Attorney Docket No.
AUROR1190-1

Serial No. 10/767,401
Customer ID: 38396

REMARKS

FIG. 1

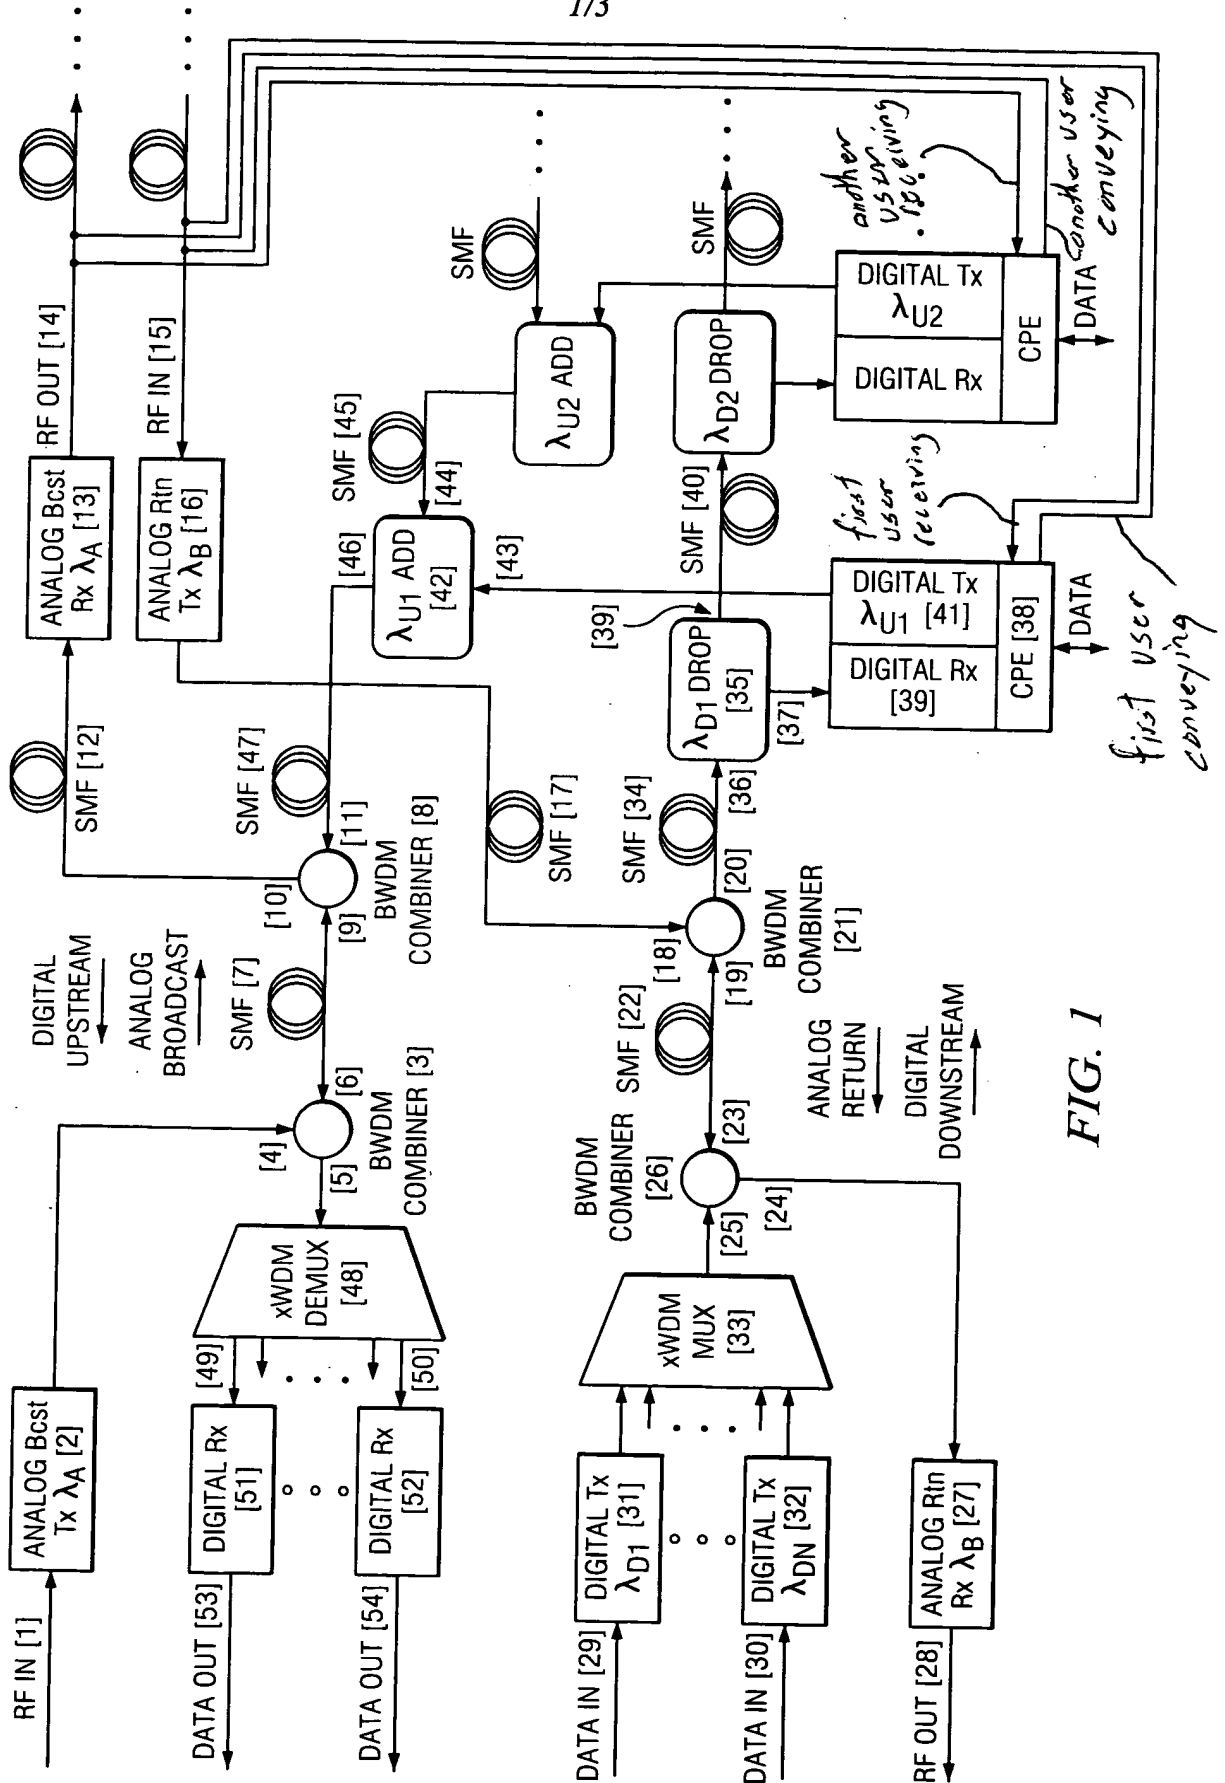
At page 2 of the Action, the Examiner objects to the drawings. Corrected replacement drawings are herewith attached and entered by amendment above. Annotated drawings are also attached to show the corrections. The corrections to Figure 1 of this application show at least one user receiving a broadcast signal and conveying a signal to an input port of the another downstream combiner as the another upstream signal.
